# Corsair Memory, Inc.

## Declaration of Product Modifications

This is to request a Class II permissive change for FCC ID: 2AAAFMRDA0047 originally granted on 03/17/2023.

MAIN\_L PCB hole position design adjustment. It can't see the change from the outside:

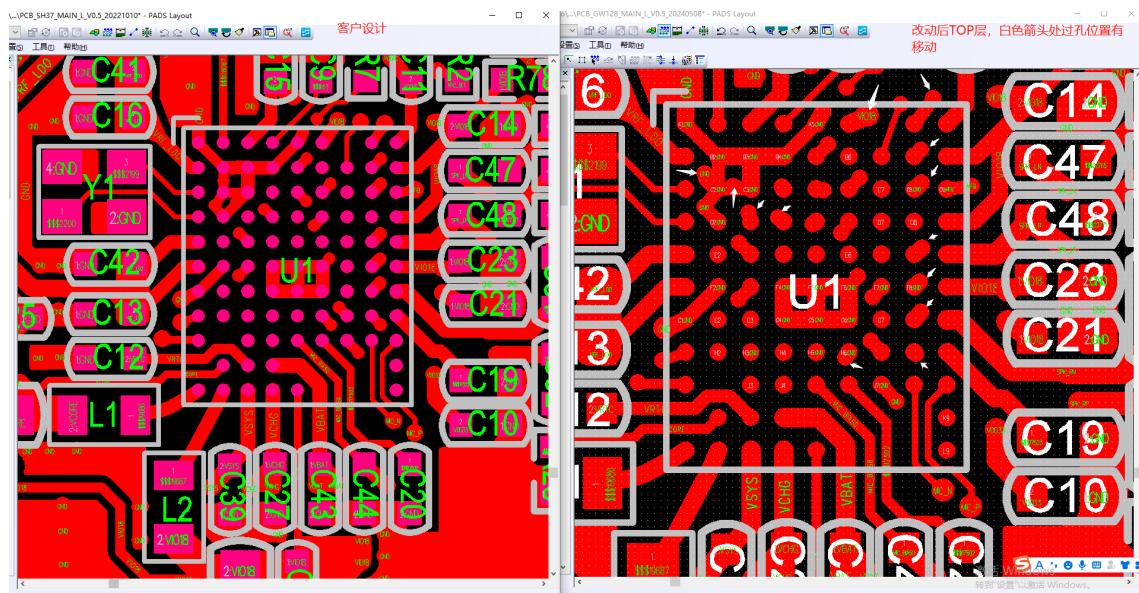
Change #1: After the change, the position of the hole at the white arrow has moved to the direction of the pad at most 0.1mm Minor pore changes on the TOP Layer

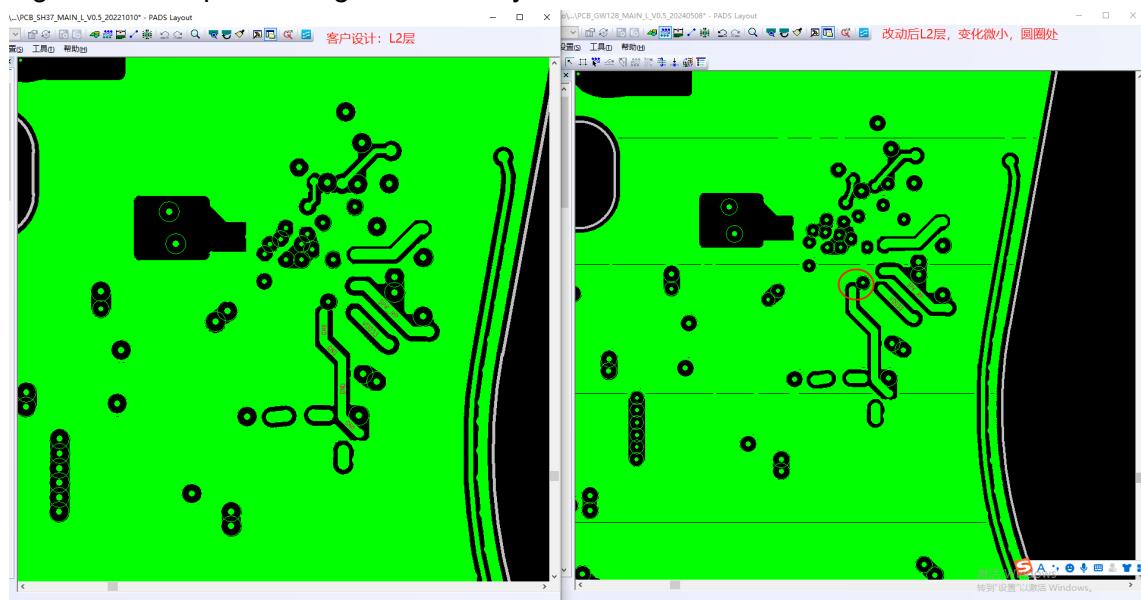
Change #2: Minor pore changes on the Layer 2

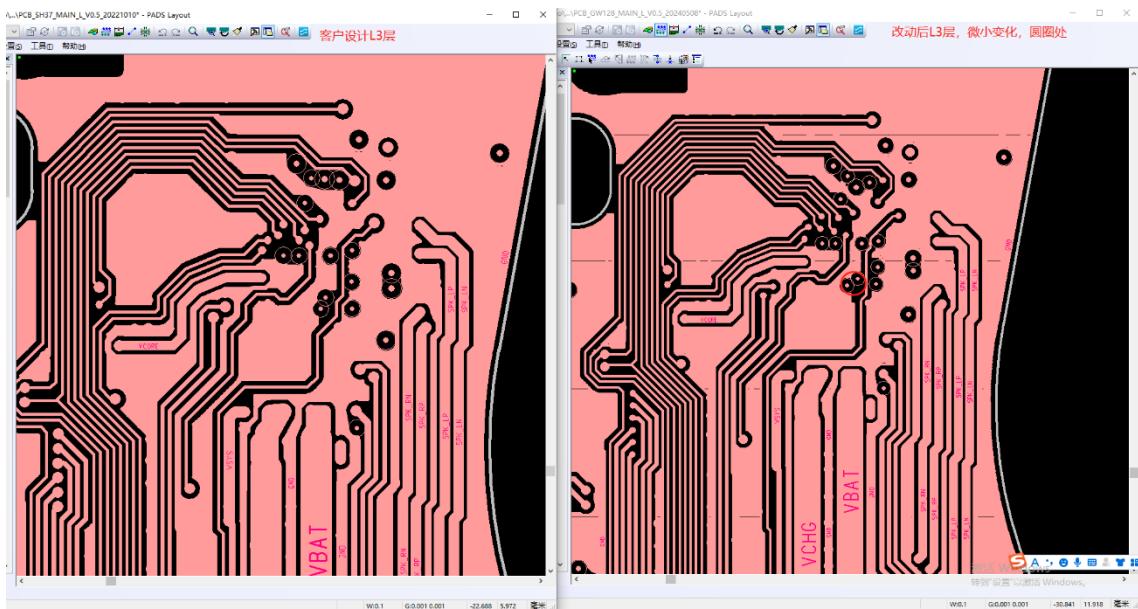
Change #3: Minor pore changes on the Layer 3

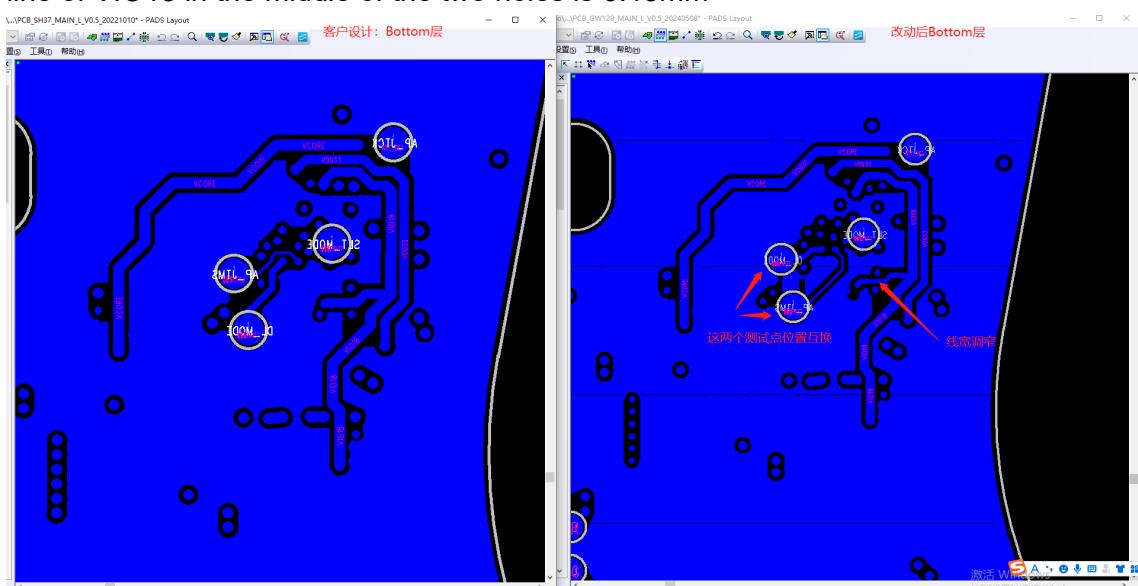
#### Change #4: Minor pore changes on the Layer 4

The positions of the two test points are exchanged. After the change, the narrowest line of VIO18 in the middle of the two holes is 0.15mm
